PRODUCT CHANGE NOTICE PCN Form (D4-E000-73)

PCN#14-016

AVA-183+

TITLE: **PRODUCT PERFORMANCE
CHANGE NOTIFICATION
REPORT**

Figure 1 Gain vs. Frequency

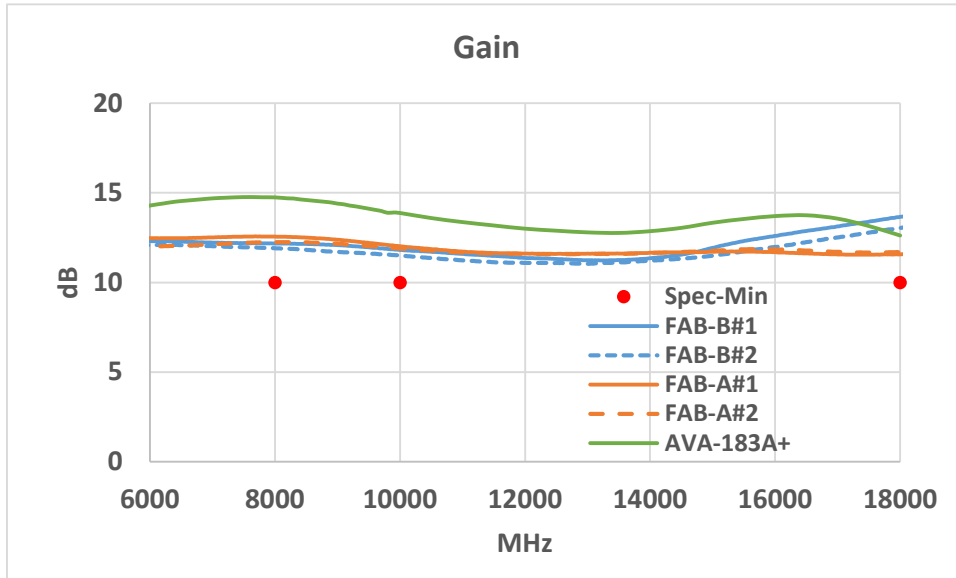
Present performance data on a representative sample of AVA-183+ with alternate Fab die (Fab "B") as compared to current production performance (Fab "A") & AVA-183A+
